CHANGE ORDER

No. 2 (Final)

Owner: St. Charles Parish
Contractor: Sealevel Construction, Inc.
Contract: Kellogg Pump Station T-Wall
Project: Kellogg Pump Station T-Wall
Owner's Contract No. P080905-5F Engineer's Contract No. 10475
Engineer: Burk-Kleinpeter, Inc.

KELLOGG T-WALL LEVEE TIE-IN
REMOVAL QTY'S

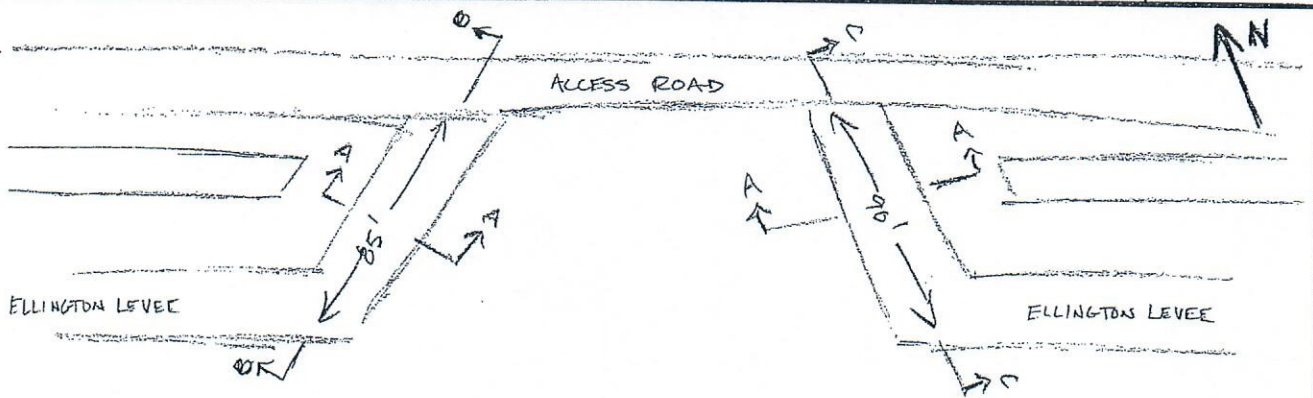
Description: Once the T-Wall transitions are in place, remove the existing levee tie-ins that connect the access road to the levee. The area will be graded to drain toward the new catch basins to be installed. It is imperative that during this process the stability of the levee and access road are not compromised. Any excavation should be done outside of the projected toe of the levee. This will increase the estimated excavation quantity by 580 CY. Excavation will be measured and paid per the contract specifications. This change in quantity will not prevent the Parish from performing a quantitative change order based on actual quantities as measured per the specifications at project close out.

$$\begin{aligned} \text{WEST TIE-IN} &= (2) \left(\frac{105.75 \text{ FT}^2}{2} \right) (13.5 \text{ FT}) + (105.75 \text{ FT}^2) (58 \text{ FT}) = 1,427.625 \text{ FT}^3 + 6,133.50 \text{ FT}^3 \\ &= 7,561.125 \text{ FT}^3 \times \left(\frac{1 \text{ YD}}{3 \text{ FT}} \right)^3 = 280.04 \text{ CY} \end{aligned}$$

$$\begin{aligned} \text{EAST TIE-IN} &= (2) \left(\frac{105.75 \text{ FT}^2}{2} \right) (13.5 \text{ FT}) + (105.75 \text{ FT}^2) (63 \text{ FT}) = 1,427.625 \text{ FT}^3 + 6,662.25 \text{ FT}^3 \\ &= 8,089.875 \text{ FT}^3 \times \left(\frac{1 \text{ YD}}{3 \text{ FT}} \right)^3 = 299.63 \text{ CY} \end{aligned}$$

ADDITIONAL EXCAVATION = 580 CY
